**RE: 3815 Mourning Dove Place NW
Grading and Drainage Plans
Engineer's Stamp Date: 07/03/23
Hydrology File: G11D014D1**

DRAINAGE AND TRANSPORTATION INFORMATION SHEET (REV 6/2018)

ENGINEER'S SEAL	3815 MOURNING DOVE	DRAWN BY DEM
DAVID SOULE NEW MEXICO 14522 REGISTERED PROFESSIONAL ENGINEER		DATE 6-27-23
7/3/23	GRADING AND DRAINAGE PLAN	3815 MOURNING DOVE.DWG
DAVID SOULE P.E. #14522		SHEET # C1
		JOB #

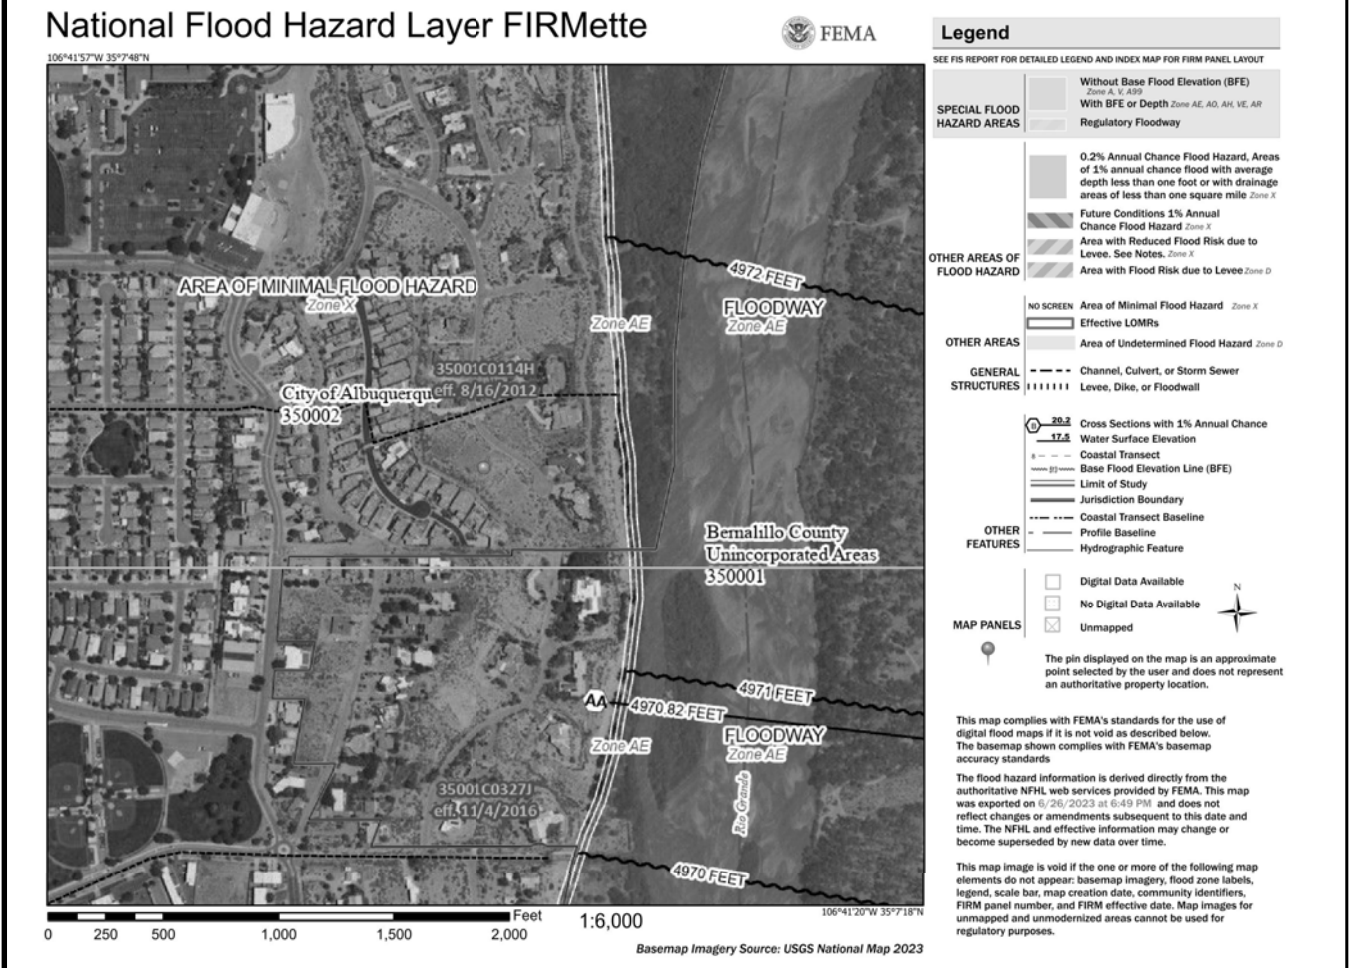
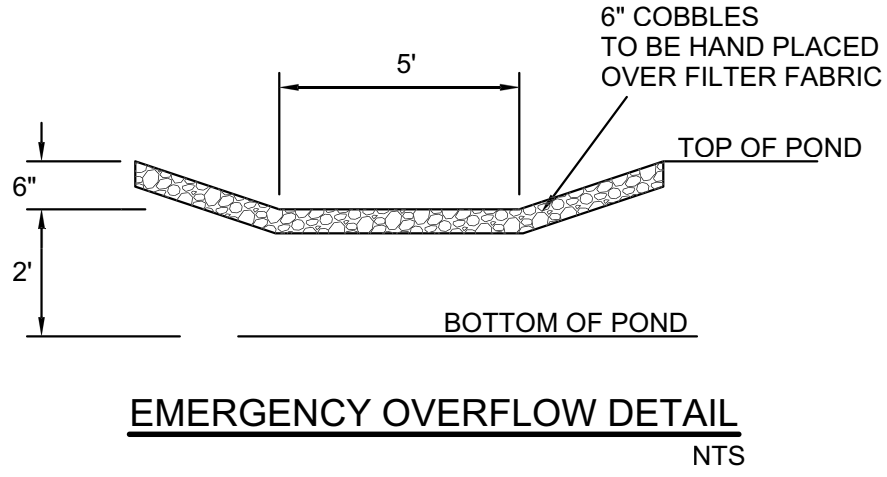
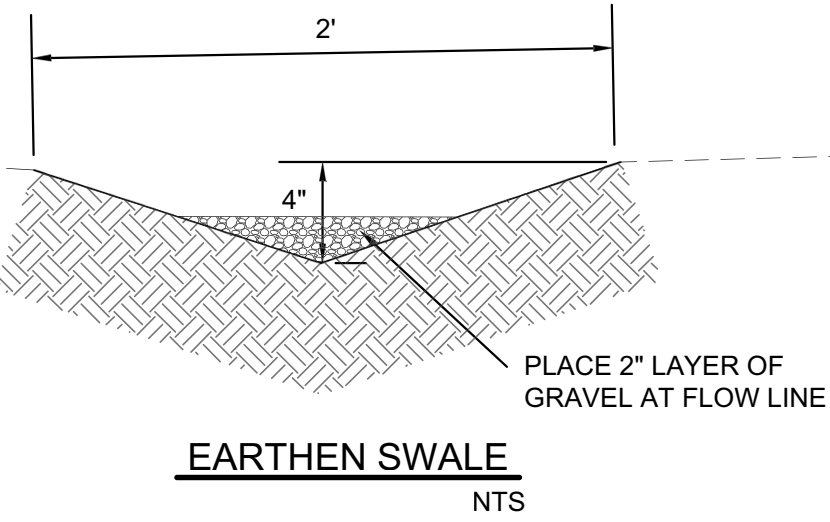
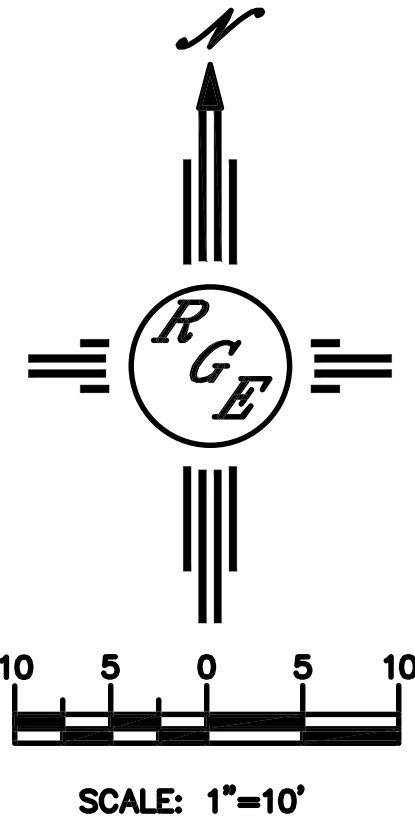
Based upon the information provided in your submittal received 07/05/2023, the Grading and Drainage Plan is approved for Building Permit and Grading Permit. **Since this site has stem walls, a pad certification is not needed for this project.** Please attach a copy of this approved plan in the construction sets for Building Permit processing along with a copy of this letter.

1. Engineer's Certification, per the DPM Part 6-14 (F): Engineer's Certification Checklist For Non-Subdivision is required.
